AGENDA
Planning and Zoning Commission
May 7, 2025 – REGULAR MEETING

I. P25-041 460 E Broadway (Hitching Post) Development Plan
Andrew Bowen

Meeting Date:	May 7, 2025	Meeting Title:	Planning Commission
Submitting Department:	Planning Department	Presenter:	Andrew Bowen
Agenda Item:	P25-041 Development Plan (St Johns Health, Hitching Post Housing Development Project)	Public Comment:	Yes

Utility Locations (Eastern Driveway)

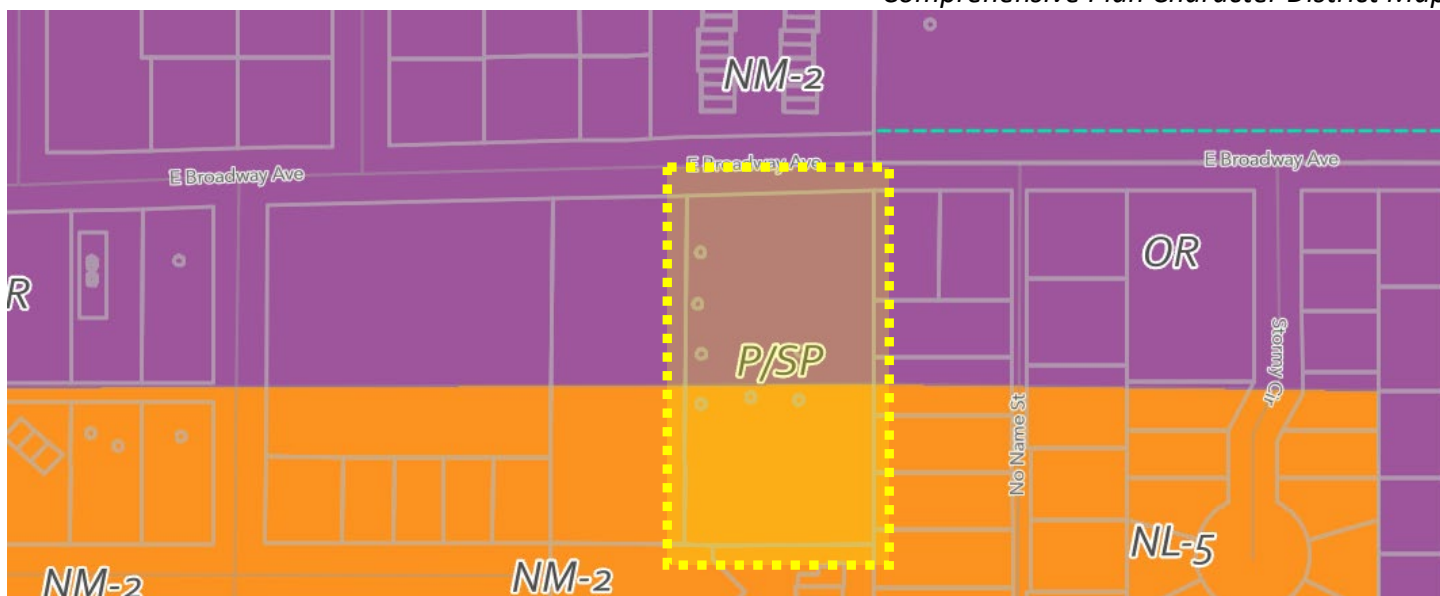
In response to comments from both the Pathways and Engineering departments, further consideration could be given to extending the sidewalk eastward along Broadway. Staff understands this alternative could be financially burdensome due to utility locations as shown below:

C3.20

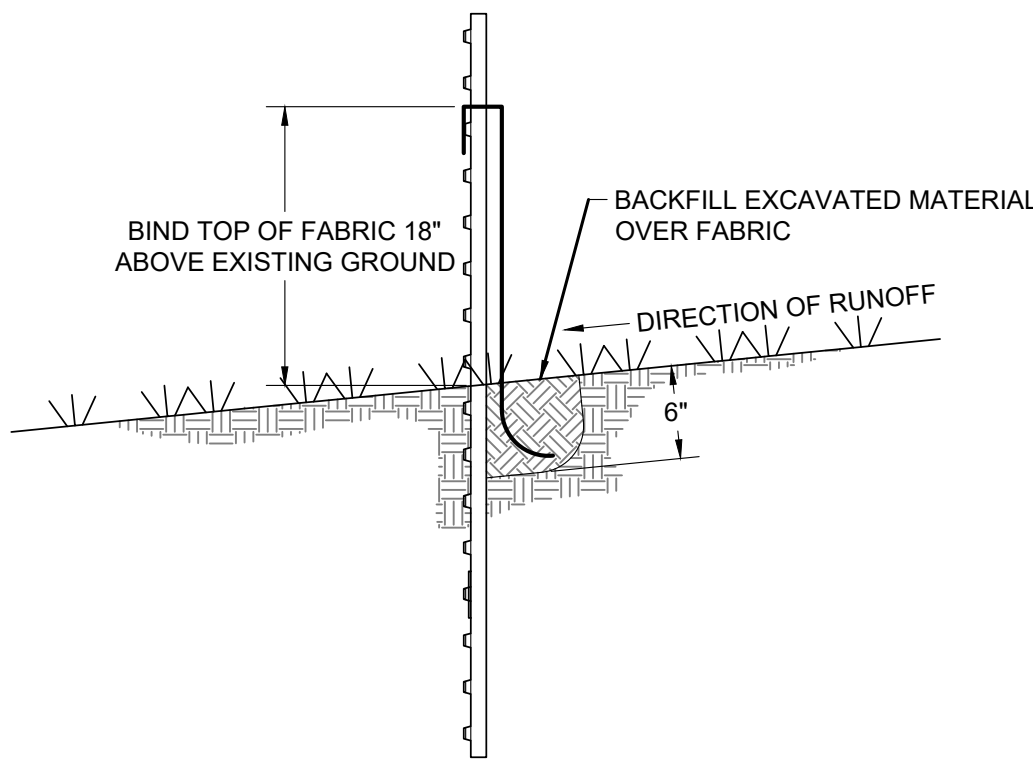
- 7) Landscaping in the right of way should be grass or a standard street frontage.
- 8) Provide drawings to scale, C3.20 did not scale correctly in PDF.
